SUBJECT: VERMONT YANKEE NUCLEAR POWER STATION – GROUNDWATER  
MONITORING INSPECTION REPORT 05000271/2011010

**Report No.:** 05000271/2011010

**IR 05000271/2011010; 05/09/2011 – 08/30/2011; Vermont Yankee Nuclear Power Station; Contaminated Groundwater Monitoring and Effluent Controls Inspection.**

Figure 1, Vermont Yankee Groundwater Monitoring Well Map\*

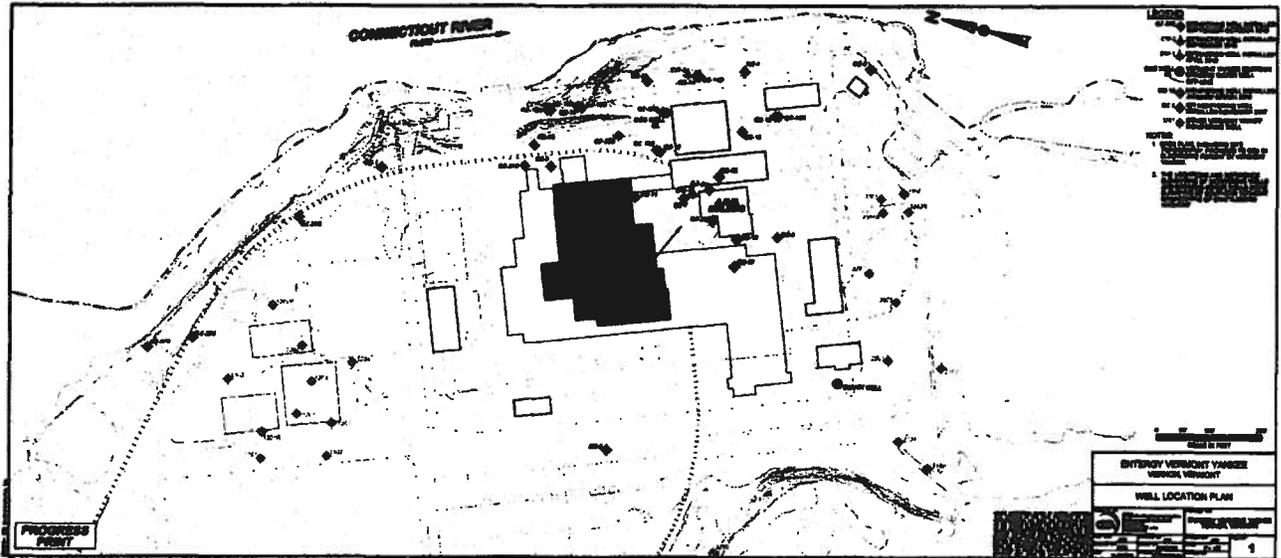
The initial detection of the tritium leak was in monitoring well GZ-3 (see Attachment A, Figure 1) located on the Connecticut River bank. The source of the contamination was not readily discernable due to an absence of monitoring wells adjacent to the plant systems, structures and components (SSC) that contain radioactive fluids, as
